PROJECT
**240 COUNTY ROAD, 4 BATH
ONTARIO, KOH IGO**

CLIENT
**LOYALIST TOWNSHIP - MILLHAVEN
ADMIN BUILDING**

DRAWING
**STANDARD & UNIVERSAL
WASHROOM DETAILS**
ADDENDUM COMMENTS

PROJECT NO. 223-056

1 UPPER REFLECTED CEILING PLAN
SCALE: 3/16" = 1'-0"

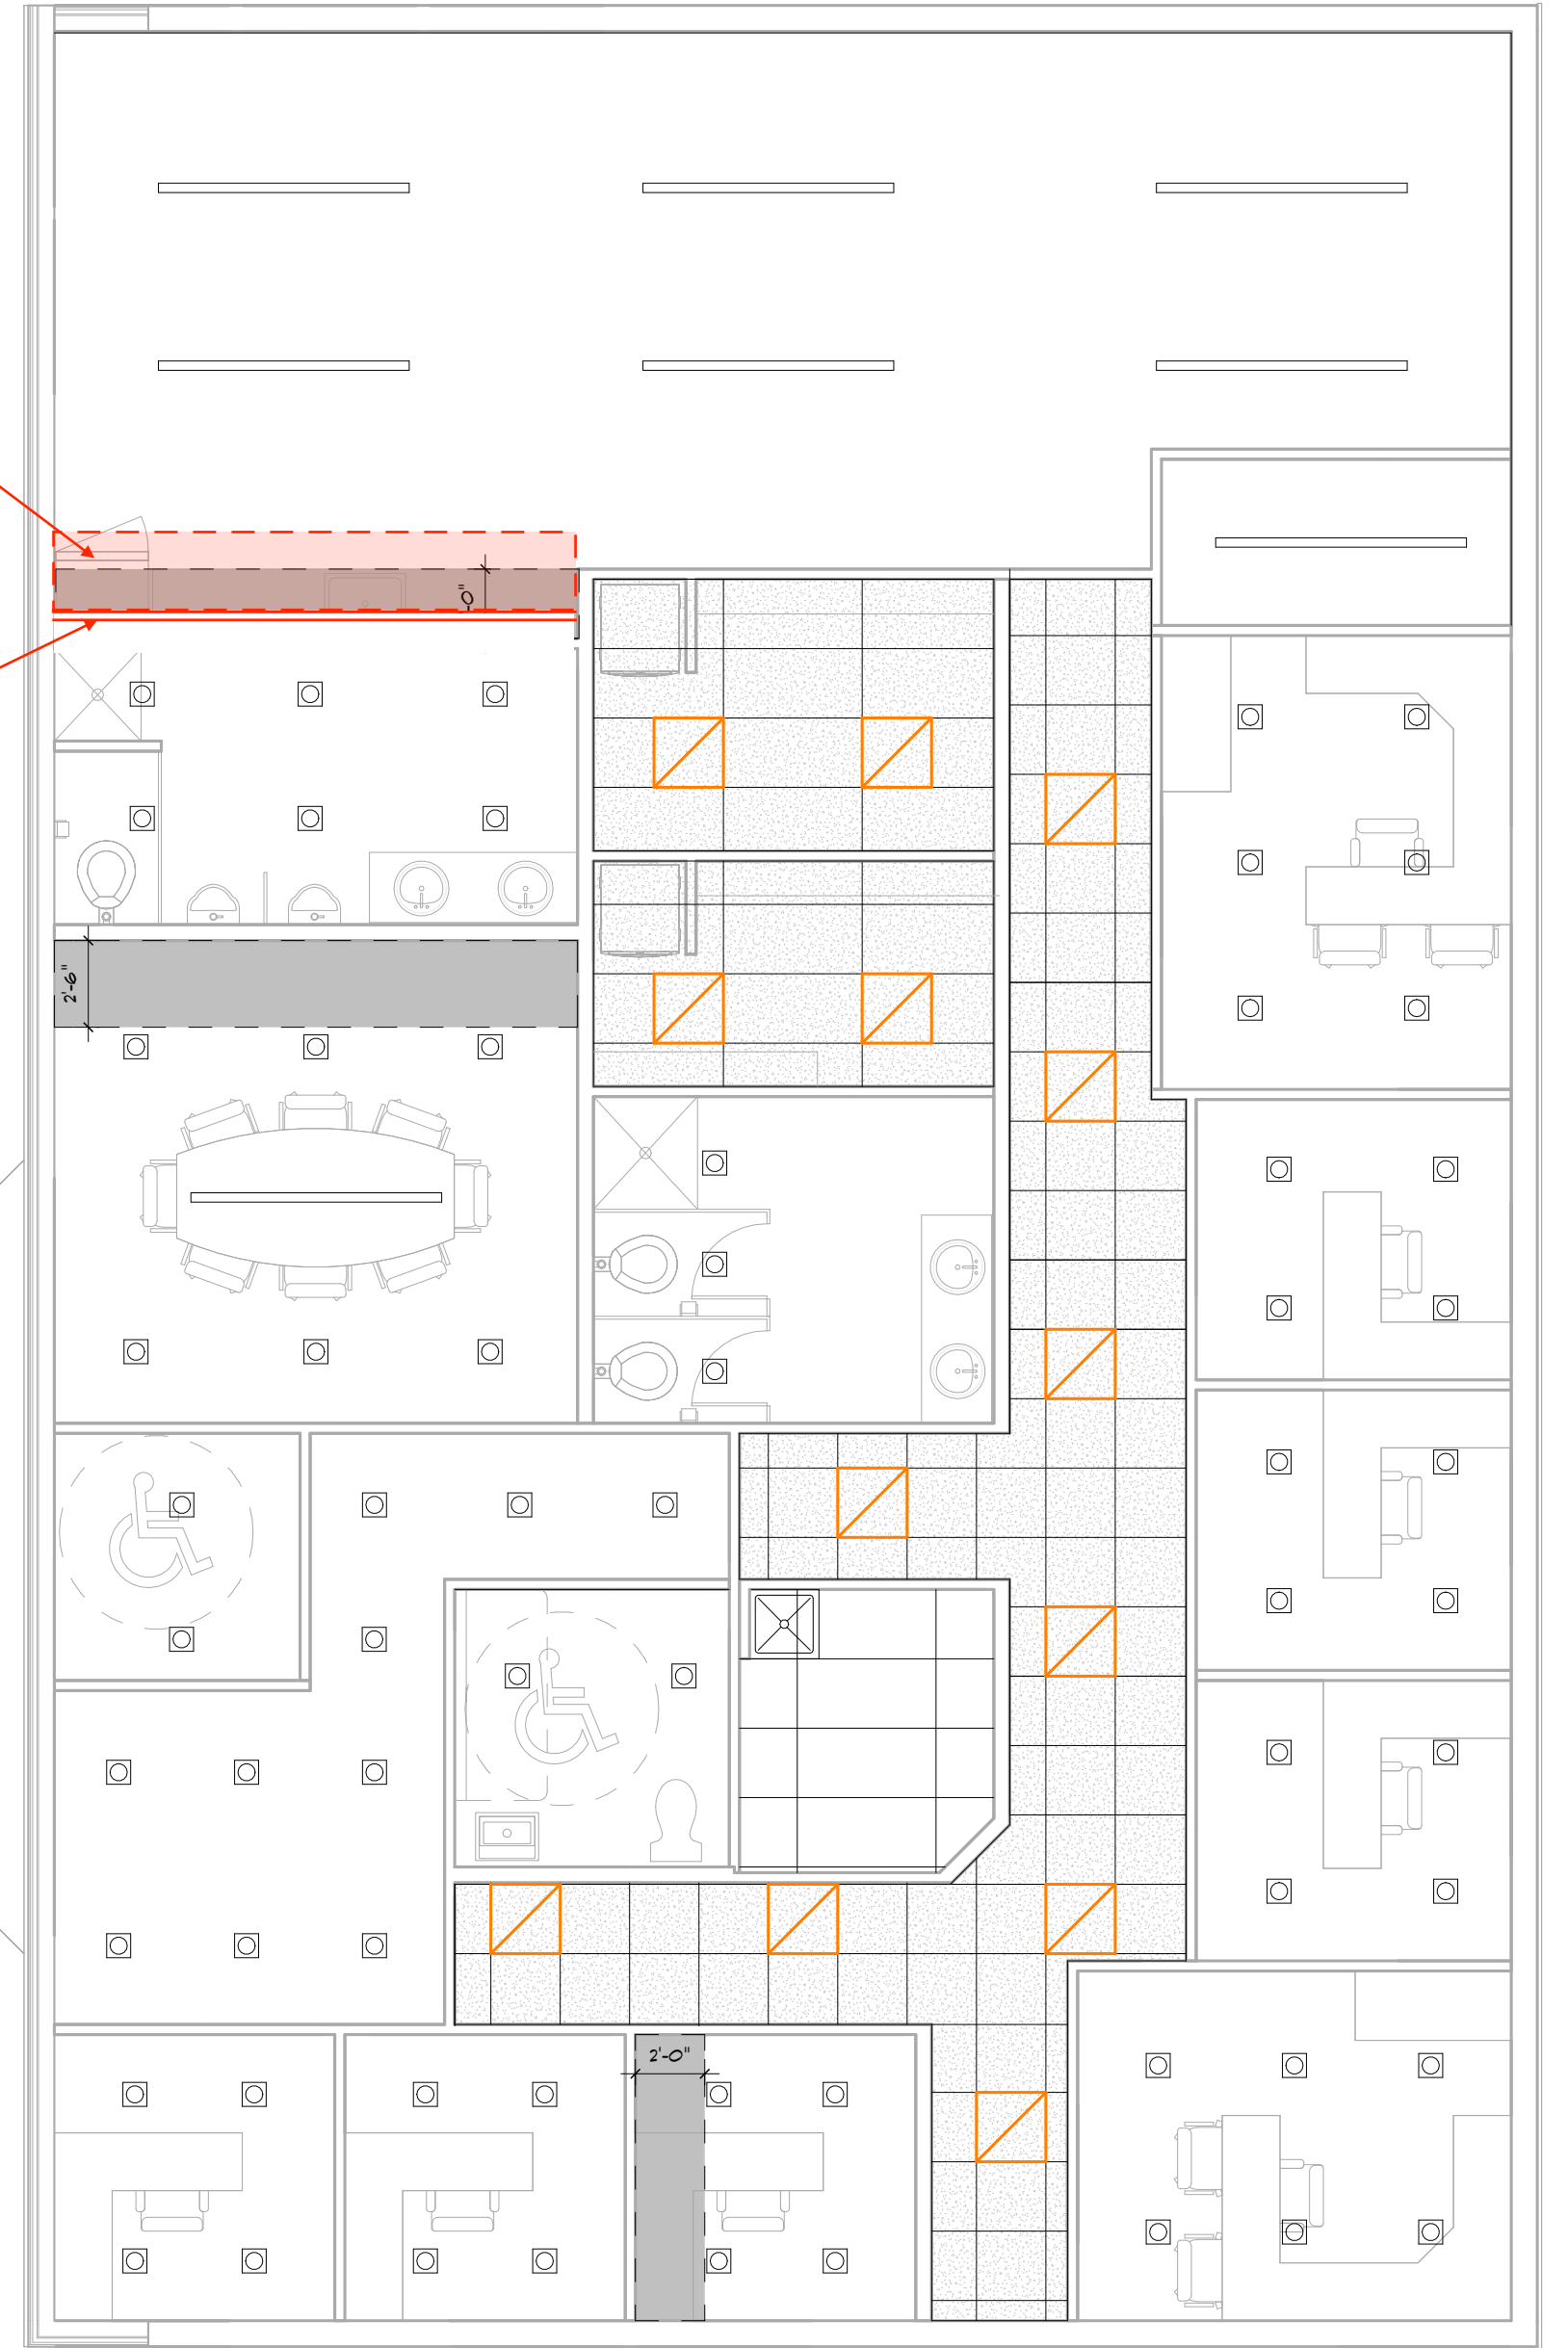
move bulkhead 12"
Move wall 12" as per plan A.3
